*[ Hybrid-III50th Head Assembly ; Chin hit Neck ]*

**Head Chin and Neck (Others and JASTI)**

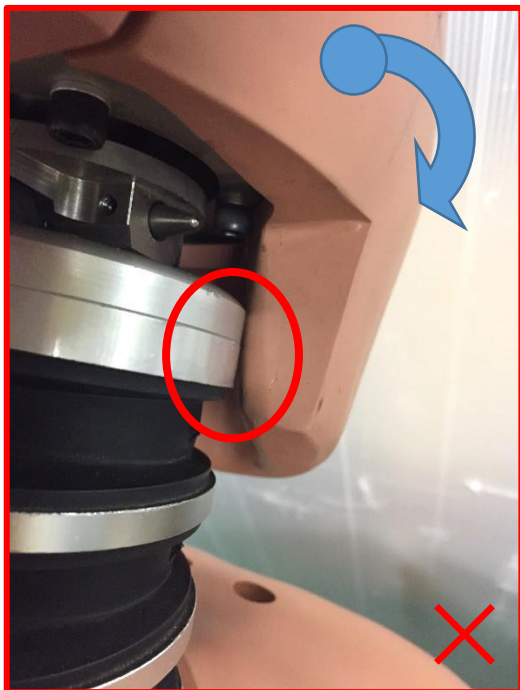
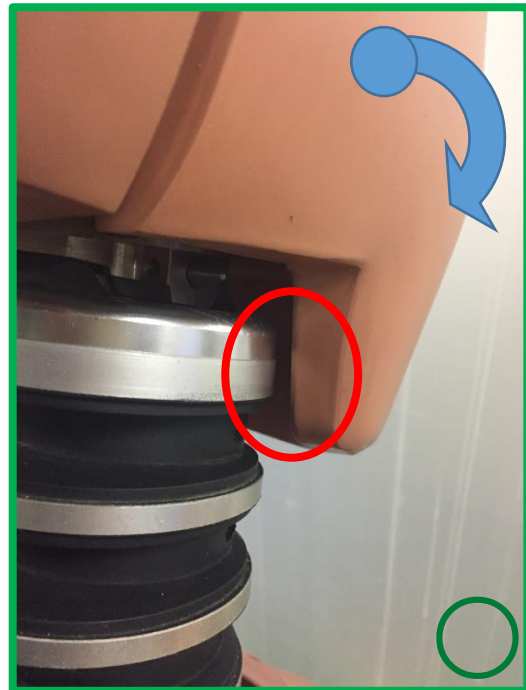
- Market reports : Hybrid-III50th Head Chin width too narrow ;  
Chin part hits the Neck by Neck Certification test or Real car crash test.,  
Head assembly should be free moving without contacting Neck.

**The cause of trouble. : Chin Inside width is narrower than Neck**

**Wrong ; Head Chin contact Neck**

**Correct ; Head Chin is free to Neck.**

Head Assembly parts No. [780-51-61X](#) ( for 6 axis Load cell replacement.)
